UNITED STATES PATENT AND TRADEMARK OFFICE

APPLICATION NO.	FILING DATE	FIRST NAMED INVENTOR	ATTORNEY DOCKET NO.	CONFIRMATION NO.
10/766,465	01/27/2004	Ling Ma	IR-2444 CIP (2-3869)	3194
2352 7590 11/24/2008 OSTROLENK FABER GERB & SOFFEN 1180 AVENUE OF THE AMERICAS NEW YORK, NY 100368403				
EXAMINER				
KIM, S U C				
ART UNIT		PAPER NUMBER		
2823				
MAIL DATE		DELIVERY MODE		
11/24/2008		PAPER

Office Action Summary

DETAILED ACTION

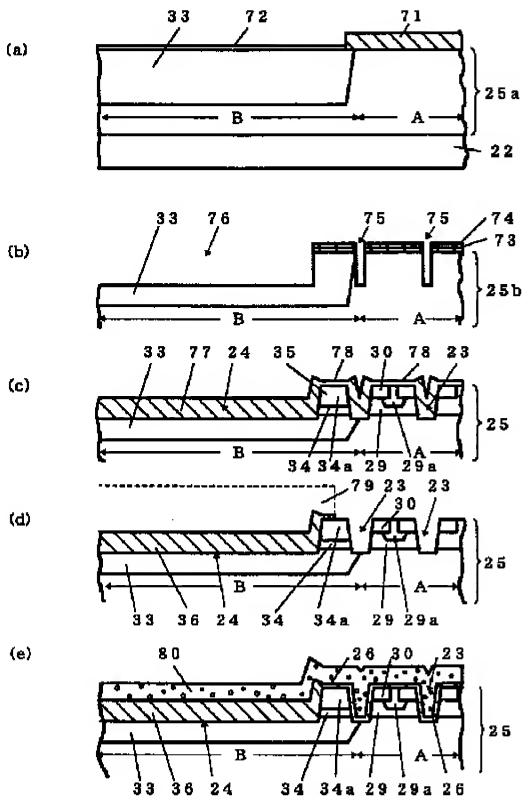
With respect to claims rejection under 35 U.S.C. 102(b), applicant argues that "the sidewall of the termination trench to be adjacent the channel region and the bottom of the termination to be adjacent a region of a conductivity type opposite the conductivity type of the channel region (i.e. a region of first conductivity type)."

In response to applicant's contention, it is respectfully submitted that **JP2000-101074 (hereafter, "Hirohiko")** discloses all the claimed limitation including "the sidewall of the termination trench to be adjacent the channel region and the bottom of the termination to be adjacent a region of a conductivity type opposite the conductivity type of the channel region (i.e. a region of first conductivity type)."below.

Hirohiko appears to show, see Fig. 4, the sidewall of the termination trench 76 (a side of a trench 76) to be adjacent the channel region 29 or 34 (paragraph 0015 & 0016, elements 29 & 39 are n type) and the bottom of the termination 76 (a bottom of the element 76) to be adjacent a region of a conductivity type 28 (note: part A is P type conductivity) opposite the conductivity type of the channel region (note: element 29 & 34 are n-type) (i.e. a region of first conductivity type).
